CSP-18001
DSP-18016

Application	General Data	
Project Name: Marlow Heights Center Location: In the southwest corner of the intersection of Riviera Street and 28th Avenue. Applicant/Address: PAAP Properties, LLC 462 Indian Greens Lane Manns Choice, PA 15550	Planning Board Hearing Date:	03/14/19
	Staff Report Date:	2/25/19
	Date Accepted:	12/14/18
	Planning Board Action Limit:	04/25/19
	Plan Acreage:	0.25
	Zone:	M-X-T
	Dwelling Units:	N/A
	Gross Floor Area:	10,176 sq. ft.
	Planning Area:	76A
	Council District:	07
	Election District:	06
	Municipality:	N/A
	200-Scale Base Map:	206SE04

STAFF REPORT

SUBJECT: Conceptual Site Plan CSP-18001
Detailed Site Plan DSP-18016
Marlow Heights Center

SITE PLAN

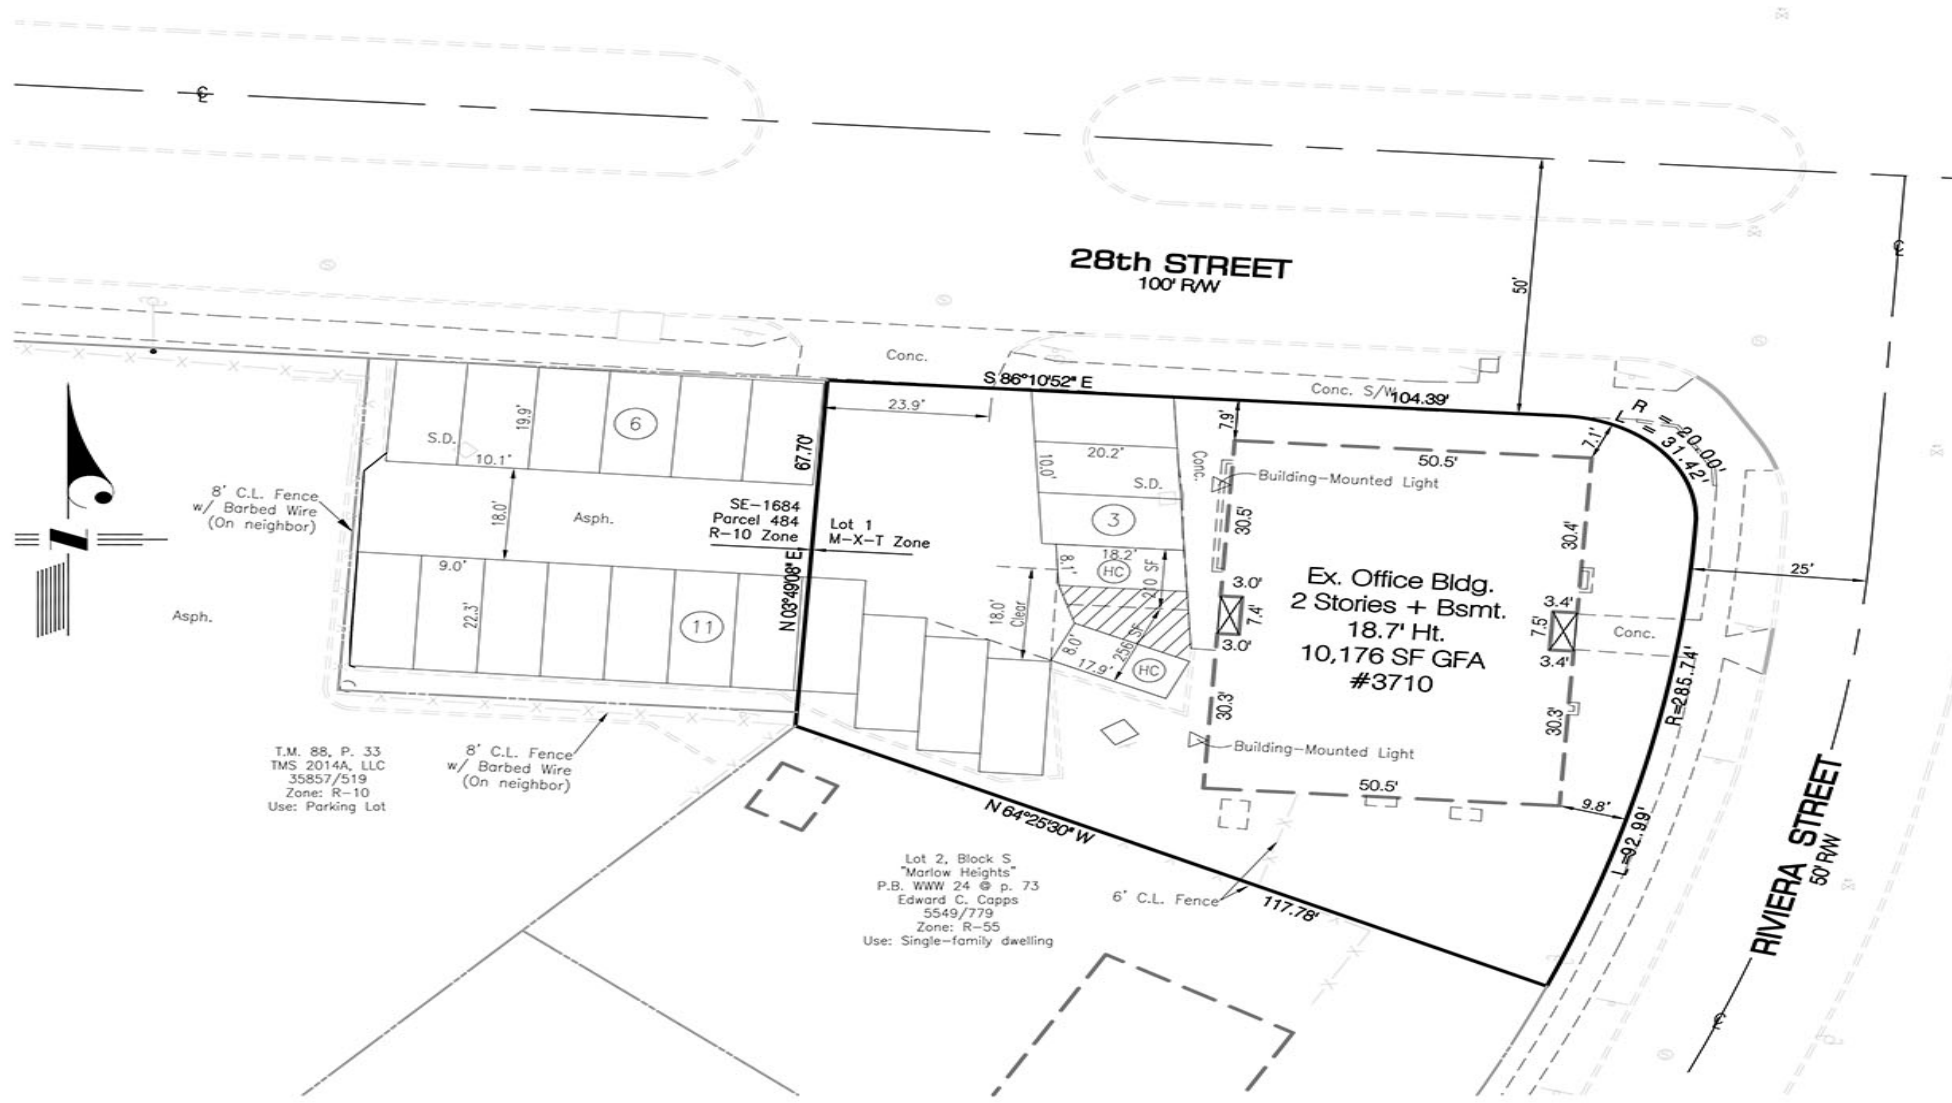
****The DSP shows 22 parking spaces; however, the parking schedule states that 21 spaces are proposed. A condition has been added to the Recommendation section of

Generally, the parking spaces and drive aisle meet those regulations, but differ in several locations. Therefore, a condition has been included in the Recommendation section of this report requiring the applicant to revise the dimension of the parking spaces and drive aisle width to either meet the minimum required in 1968 or the current requirements.

It is noted that the loading schedule shown on the plan is calculated incorrectly and has been calculated based on the uses in the building. The loading schedule should be revised, in accordance with Section 27-582, to show the required number of loading spaces for an office building or office building complex based on the square footage or GFA of the building, and is conditioned herein.

A trash facility appears to be shown on the west side of the building but is not clearly labeled on the plan. Per current aerial imagery, this is a trash dumpster; therefore, a condition has been included in the Recommendation section of this report requiring the applicant to screen or enclose the trash facility with an evergreen screen, or sight-tight fence, that is compatible with the building.

The plan shows an eight-foot-high, chain-link fence with barbwire along the west and south sides of the parking compound on the adjacent Parcel 33, with no fence on Parcel 484. Therefore, a condition has been added to the Recommendation section of this report requiring that the five-foot high, sight-tight fence be shown.

- f. Revise the parking schedule to indicate the total number of parking spaces proposed.
 - g. Correct the label of the special exception on adjacent Parcel 484 to SE-1654.

- h. Revise the number of loading spaces required, in accordance with Section 27-583 of the Prince George’s County Zoning Ordinance.
 - j. Reflect a five-foot-high, sight-tight fence abutting residential land adjacent to the side and/or rear lot line of Parcel 484, as required by Special Exception SE-1654.

- j. Revise the dimensions of the parking spaces and drive aisle to meet the minimum requirements in 1968, or meet the requirements of Sections 27-558 and 27-560 of the current Prince George's County Zoning Ordinance.
- k. Screen or enclose the trash facility with a sight-tight fence or evergreen screen.
